WECL Project Reference: 24106

**Site Address:** 142 Konini Rd, Auckland

**Description:** Proposed Extensions & Upgrades of an Existing Dwelling – Garage, Pool House

**Subject: Response to Request for Information 02 – Engineering Aspects**

**Figure 1: Screenshot from Architectural Drawings showing As built Timber Retaining Wall Elevation**

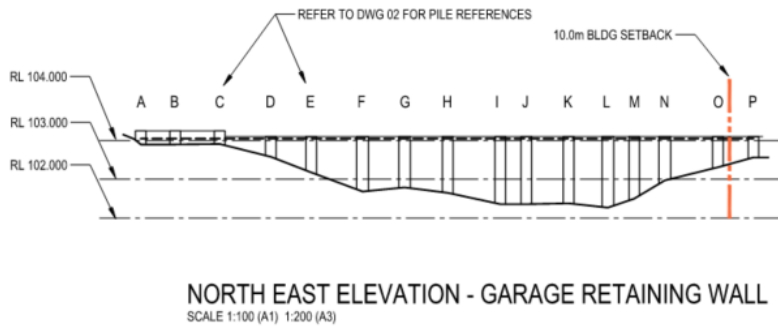
*1. The installation of the timber pile retaining wall along the eastern side of the site has already concluded, and I have received concern from the neighbours that the installation and construction of the walls, in particular the piles, may not have been carried out in accordance with the geotechnical report and engineering plans. Please provide geotechnical completion reports to confirm the methodology of the wall construction and the stability of land.*

With respect to construction, we confirm that the timber retaining wall has been built in accordance with the design intent. The latest architectural drawings (sheet 3368-RC-06) show the as-built wall elevation, with retaining heights under 2 m. 300 SED timber poles were used, augered into 600 mm diameter holes with embedment depths of approximately 4 m at maximum height locations.

**Figure 2: Screenshot from Architectural Drawings showing As built Plan and Foundation Extension Required**

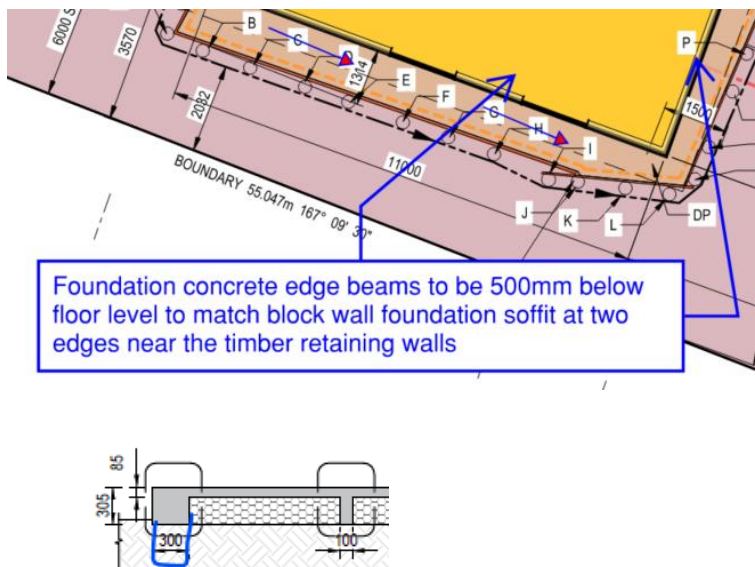
We note a minor variance between the geotechnical report (Section 5.1.10) and the as-built condition: the garage is offset 1.3 m from the timber retaining wall rather than the 1.5 m originally indicated. To address this, the garage concrete foundation edge beam will extend an additional 200 mm below

ground to align with the block wall foundation depth (~500 mm). This adjustment will be straightforward to implement during garage foundation excavation and is already confirmed on the plans.

Figure 3: Screenshot from Architectural Drawings showing Layout prior to Construction/Proposed

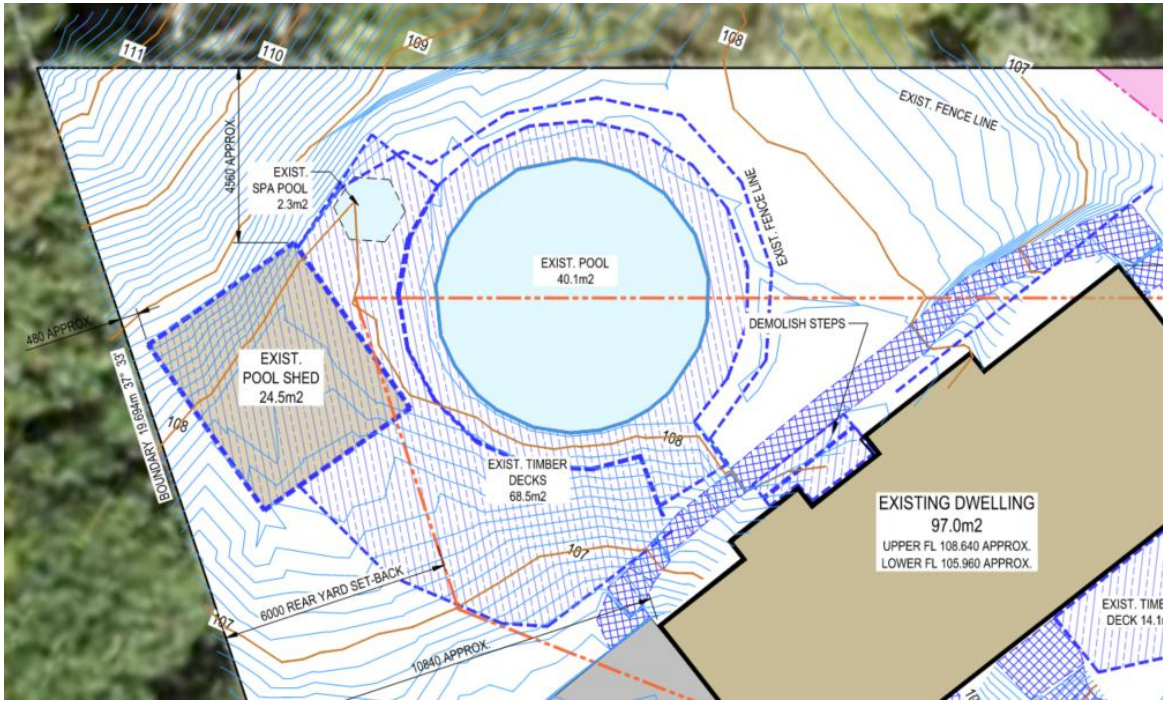
*2. Same with the pool and decking. Please confirm that the earthworks carried out at the top of the site, to establish the pool and decking structure, are in accordance with the provided earthworks plan, and provide a completion report (or similar) to demonstrate the effects of cut/fill carried out here, as well as the structures, on the stability of land; noting that this is close to a steep drop.*

We confirm that the earthworks undertaken at the pool and decking area were carried out in accordance with the approved earthworks plan and are minor compared to those completed at the garage area. Figures 3–6 illustrate the existing, proposed, and partially constructed layouts.

The new pool is partly located on the footprint of the previous pool and partly on an area of raised deck. The surrounding contours are gentle, as shown in Figure 3, and the vegetation to the south of the pool

**Figure 7: Photo showing current Construction/Proposed Layout**

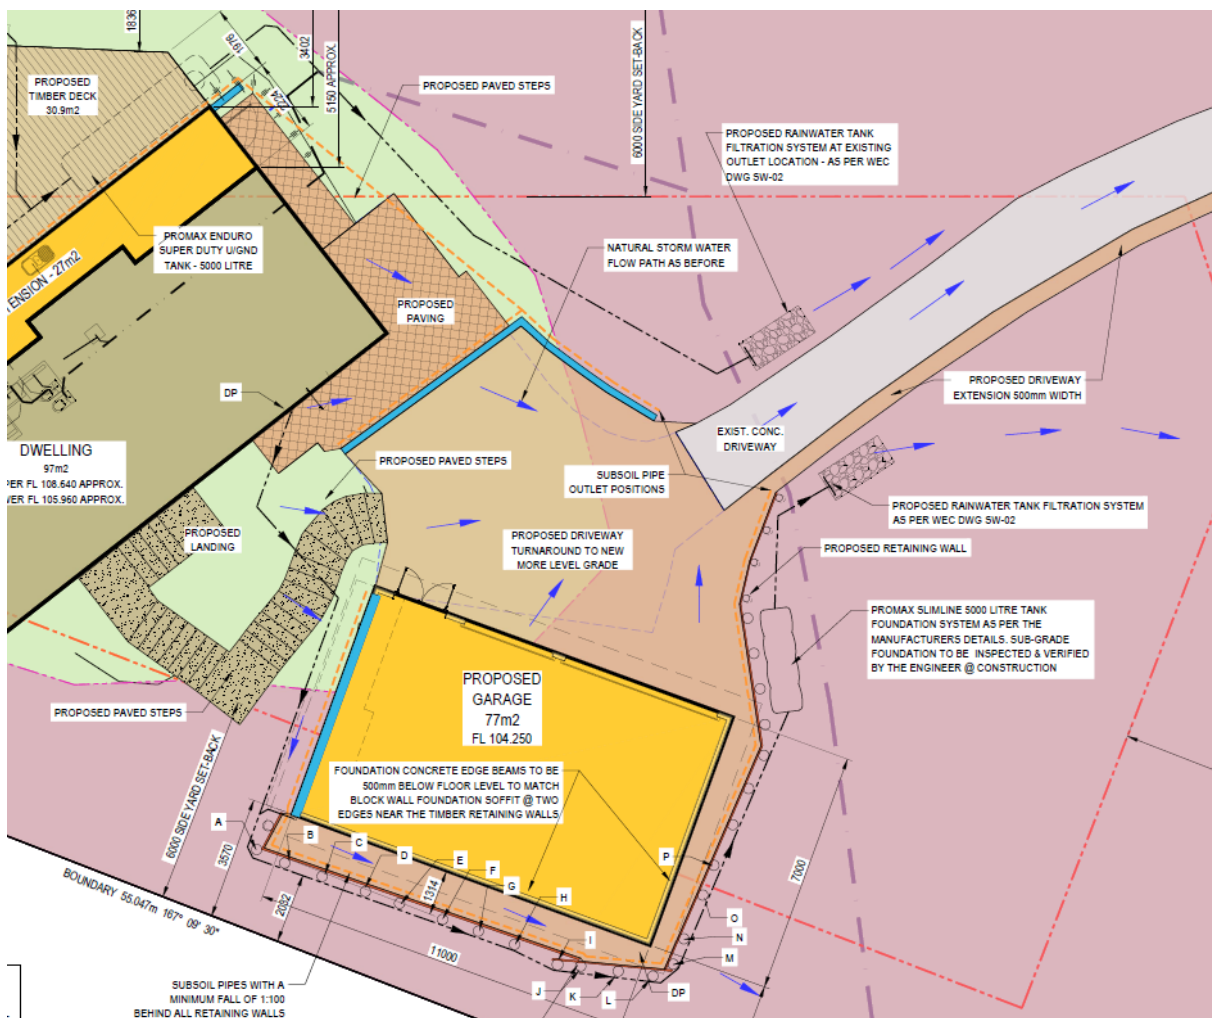
3. The design of the on-site stormwater piping and tanks is different between the architectural plans (Proposed Site Plan) and the stormwater mitigation report (stormwater system markup of the proposed site plan). The main difference is the discharge of stormwater to the west (site plan) or east (stormwater markup). Please provide additional assessment to demonstrate that discharge of stormwater from the proposed outlets, but in particular at the top of the site, meet the general standards under E8.6.1, including that they will not cause or increase scouring or erosion at the point of discharge of downstream, or damage to other properties.

We acknowledge that the outlet and tank locations differ between the latest Site Plan and the older stormwater markup. These changes have been reviewed in detail in the latest stormwater memorandum letter, which confirms the revised layout meets design intent and stormwater requirements.

The updated outlets discharge to stable paths as shown on the latest Site Plan (Figure 7), with attenuation and energy dissipation measures ensuring compliance with E8.6.1. The system will not cause or increase scour, erosion, or downstream effects, and overland flows in extreme events are safely directed towards the existing stormwater system. Refer to the stormwater memorandum letter for further details.

Figure 8: Photo showing current Construction/Proposed Layout

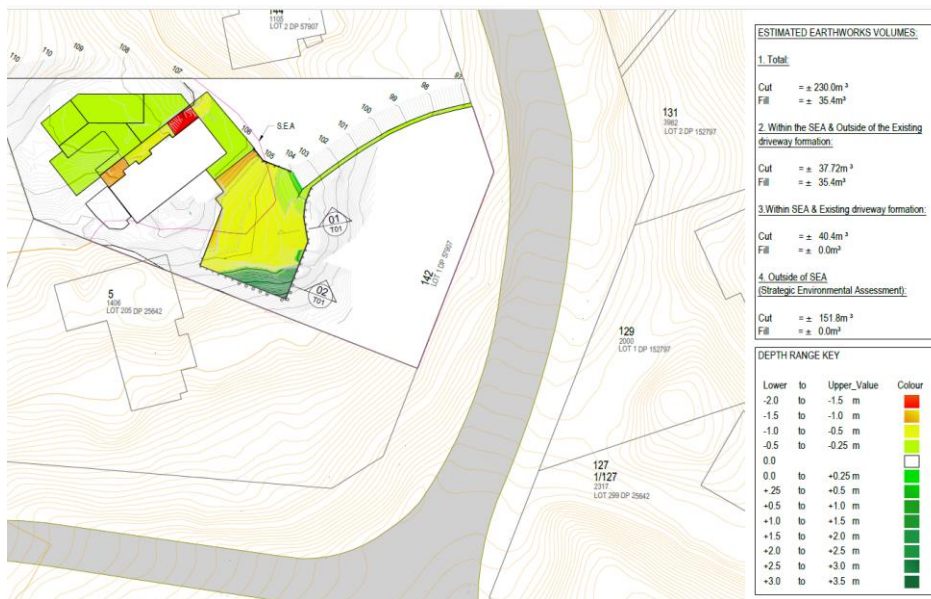
4. I note that the Applicant has not provided a summary of earthworks area and volume for the SEA and non-SEA areas of the site. As different consenting thresholds apply in each area, that breakdown is essential to determine compliance and for the assessment of effects. A table in the following format would provide that information to Council:

The breakdown of earthworks within the SEA and non-SEA portions of the site was included in the documentation previously provided (Sheet ISO). For ease of reference, the information is reproduced in Table 1 below. These figures have been cross-checked against the Earthworks Engineering Drawings (Sheet ISO), with a relevant screenshot included in Figure 8.
